## **HAWTHORNE PLACE SUBDIVISION, RESUBDIVISION OF LOT 15 REVISED**

APPLICATION NUMBER 10 DATE May 17, 2018  
APPLICANT Hawthorne Place Subdivision, Resubdivision of Lot 15 Revised  
REQUEST Subdivision

# DETAIL SITE PLAN

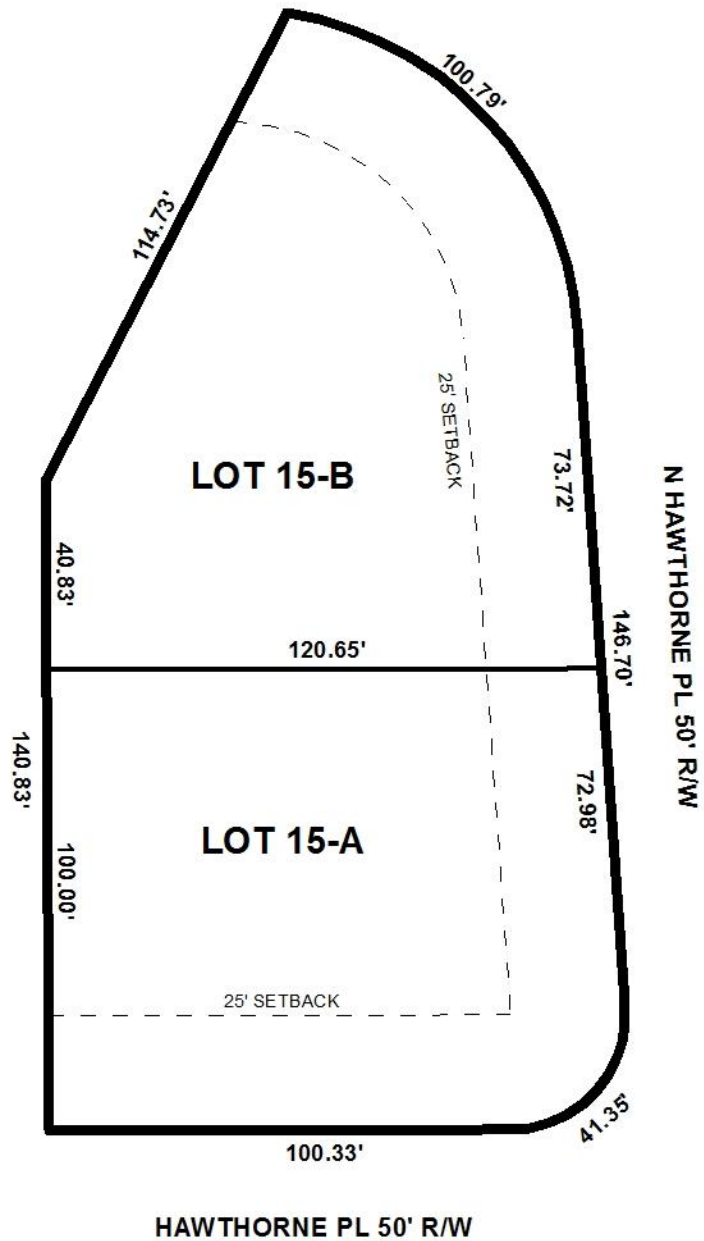
The proposed lots front Hawthorne Place and Hawthorne Place North, both minor streets with ribbon curb and gutter and existing compliant rights-of-way of 50 feet. The site appears to also have a compliant corner radius, making no dedications necessary.

The preliminary plat illustrates a 25' minimum building setback line all frontages. This should be retained on the Final Plat, if approved.

In accordance with Section V.D.2. of the Subdivision Regulations, the proposed lots each exceed the 7,200 square foot minimum lot size requirement for lots served by public water and sewer systems. The lot size information for each lot is depicted in both square feet and in acres on the preliminary plat and should be retained on the Final Plat, if approved.

It should be noted that there is an existing dwelling that straddles the proposed lot line. The applicant states that they plan to remove the existing dwelling, and build new residences on the new lots. If the proposed Subdivision is approved, the applicant should obtain a demolition permit for the existing dwelling prior to the signing of the Final Plat so that there is not a zoning violation caused by such approval.

As a means of access management, a note should be placed on the Final Plat, if approved, stating that each lot is limited to one curb cut each, with the size, location and design to be approved by Traffic Engineering and conform to AASHTO standards.

- 1) Obtaining a demolition permit for the existing dwelling prior to the signing of the Final Plat;
- 2) Retention of 25' minimum building setback line along all frontages;

- 3) Retention of the lot size information in both square and in acres on the Final Plat;
- 4) Placement of a note on the Final Plat stating that both lots are limited to one curb cut each, with the size, design and location of the curb-cut to be approved by Traffic Engineering and conform to AASHTO standards;
